**BEFORE THE PUBLIC UTILITY COMMISSION  
OF OREGON**

Docket No. LC 77

In the Matter of ·  
PACIFICORP, dba PACIFIC POWER,  
2021 Integrated Resource Plan.

Opening Comments of  
NW Energy Coalition

**Figure 9.37 – 2021 IRP Preferred Portfolio Energy Efficiency (Class 2 DSM) and Direct Load Control Capacity (Class 1 DSM)**

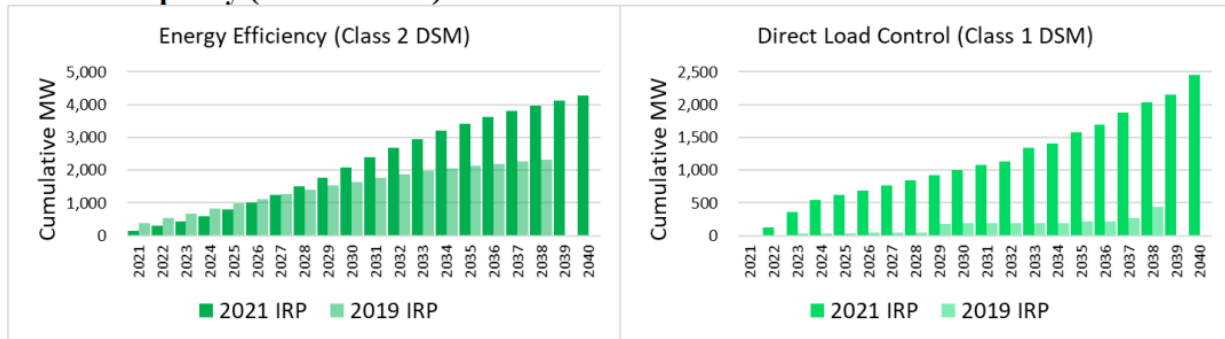
The energy efficiency (Class 2 DSM) effort continues to progress, and as shown in Figure 9.37, indicates a substantial upswing continuing after the mid-2020s, in comparison to previous IRPs where energy efficiency tended to decline year-over-year after that point.

The rapid uptake of demand response, also called direct load control (Class 1 DSM) to distinguish that from rate-design induced demand response (Class 3 DSM, price response and load shifting), is a major new development, after many years of low ambition and long lead times. The Preferred Portfolio anticipates 549 MW of new DR by 2024 – a level achieved only in the late 2030s in the 2019 IRP.

We applaud this recognition at last of DR potential, while noting that achieving this ambitious early target will require considerable effort by the Company and effective coordination with customers and suppliers. The anticipated value of DR for balancing and reliability in a cost-

**Figure 1.4 – 2021 IRP Preferred Portfolio New Solar Capacity\***

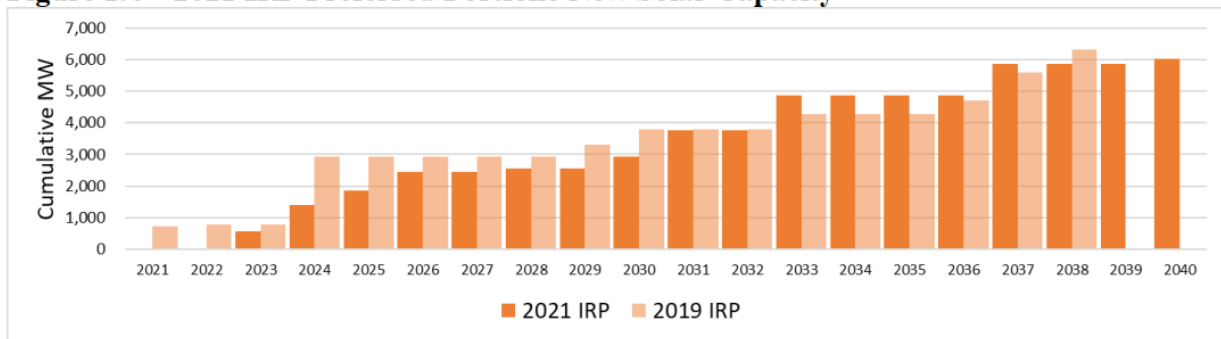
NWEC is also heartened by the continued expansion of renewable and storage resources in the 2021 IRP, as shown in Figures 1.4, 1.5 and 1.6.
